REVIEW COMMENTS

FILE #SPR-95-48

TITLE HEADING: Site Plan Review - 15,200 s.f.
Building

LOCATION: 1003 Winters Avenue

DETAIL To Lower Manhole

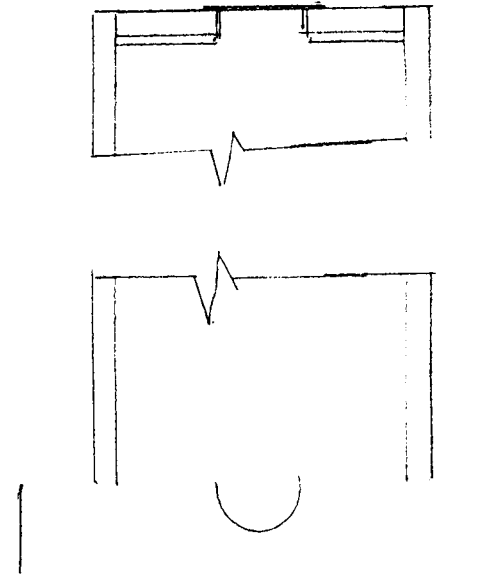
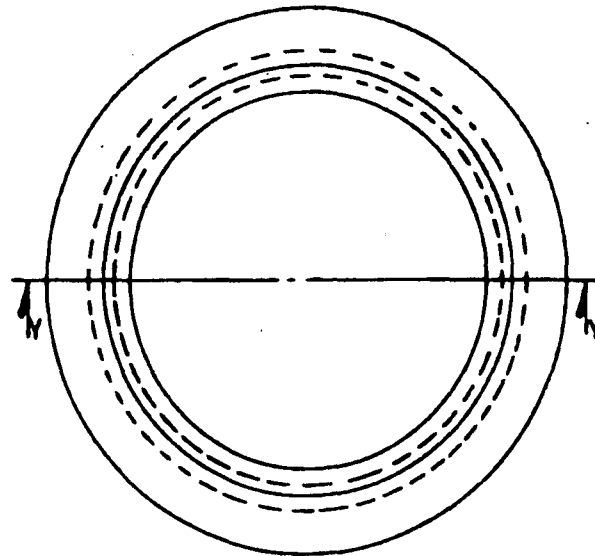
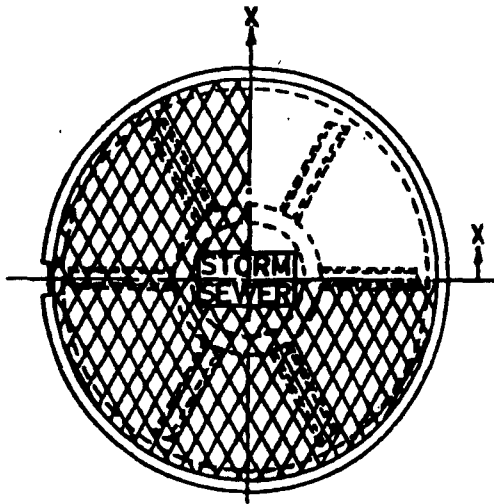
Show detail for lowering existing manhole since this is a 60" diameter manhole.

1. Detail for existing manhole is attached with cut sheet showing inverted cover.
2. Landscaping will be done on lot 2 in the future. Drawings will be submitted for your review and approval. Landscaping to be of similar type as lot 1.
3. We propose to move the retention pond 10' East of present location on drawings due to the water main 2' beneath pond to prevent possible freezing.
